BlueRobotics

Item Number: BR–103940	Description:
Unpop. PCB: BR–103940–001 RevC	PCBA: BR–103940–002 RevC
Size: A4	Date:
KiCad E.D.A. 10.0.3	Sheet: / Id: 1/1

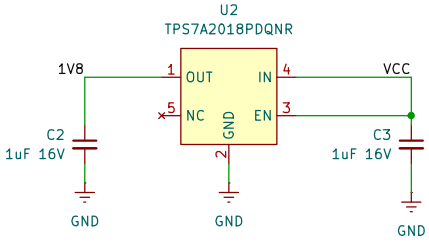
eCHANGELOG
Rev A:
– Initial revision
Rev B:
– Add voltage regulator and level shifting
Rev C:
– Slightly reduce board width and move TMP119 down to improve manufacturing

Even though the TMP119 Supports 1.7V – 5.5V we need a regulator and level shifting to support a 5V supply with 3V3 logic
